Caterpillar Motoren GmbH & Co. KG product support information for medium-speed engines

Engine platform: M 43
Engine assembly: Cylinder head

No. 0022M43 – Issue 1; 25 July 2023

Tightening torque check of ignition fuel injectors

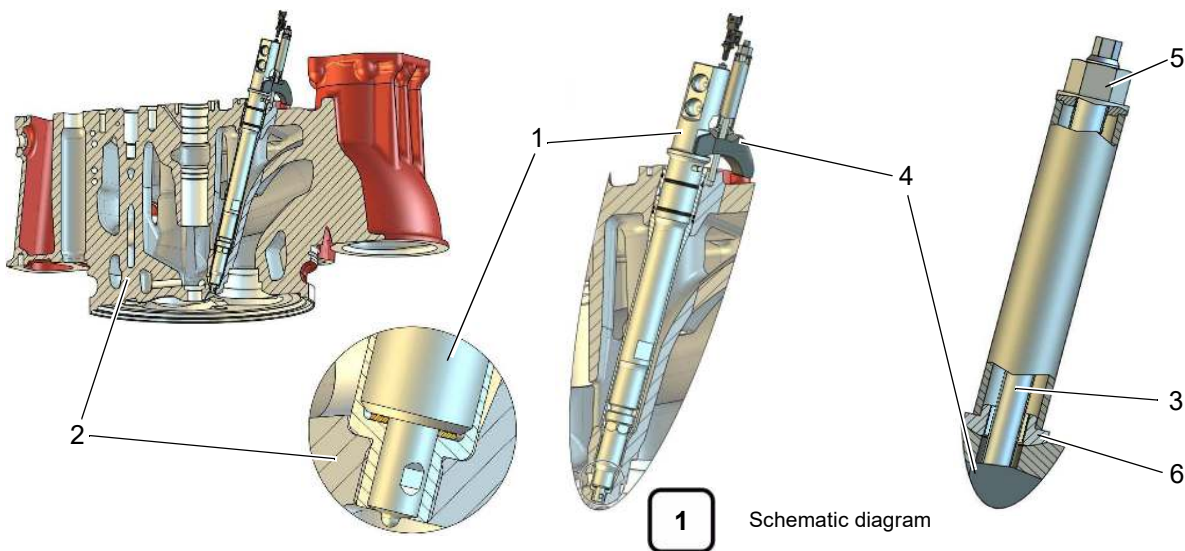
We have received information from the field that there have been isolated cases of leaks ("*blow-bys*") in the sealing area between the ignition fuel injector (1) and the cylinder head (2).

The cause investigation revealed that the required tightening torque of the collar nut (5) was, in isolated cases, lower than the specified **55 Nm**.

To avoid possible functional impairments, we recommend checking the tightening torque of the collar nut (5) on all the clamping holders (4) of the ignition fuel injectors (1) and retightening them to **55 Nm**, if necessary.

Each time an ignition fuel injector is reinstalled or replaced, the tightening torque of the collar nut must be checked again after another **200 engine operating hours**.

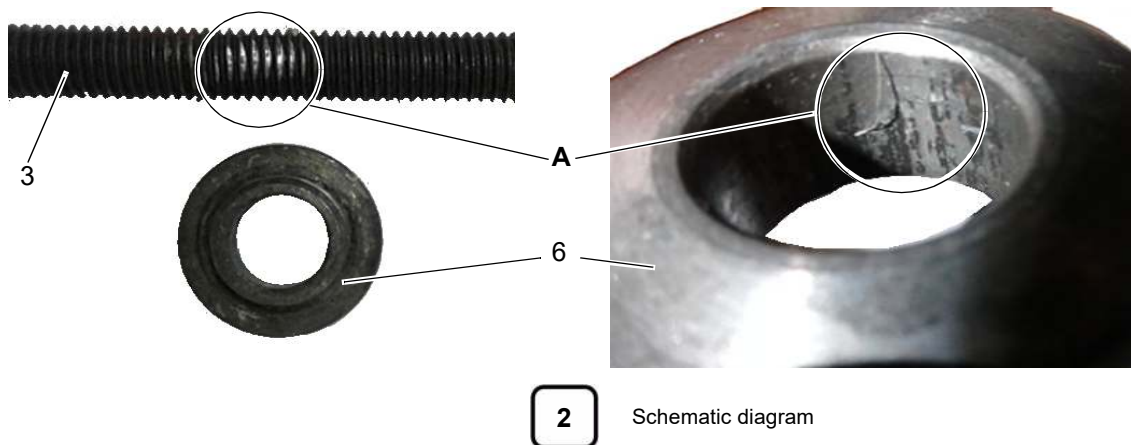
Furthermore, when installing the clamping holder (4), it is imperative to ensure that the stud (3) and the centering piece (6) are aligned to each other when tightening the collar nut (5). If the stud is bent (*deformed*) or the centering piece leans over due to improper tightening, the stud bolt will come into contact with the centering piece in the lower area (**Fig. 2/A**). This can subsequently lead to a fracture in this area.

If contact marks are found on the stud, as shown in **Fig. 2/A**, the stud (3) must be replaced (see last page)!
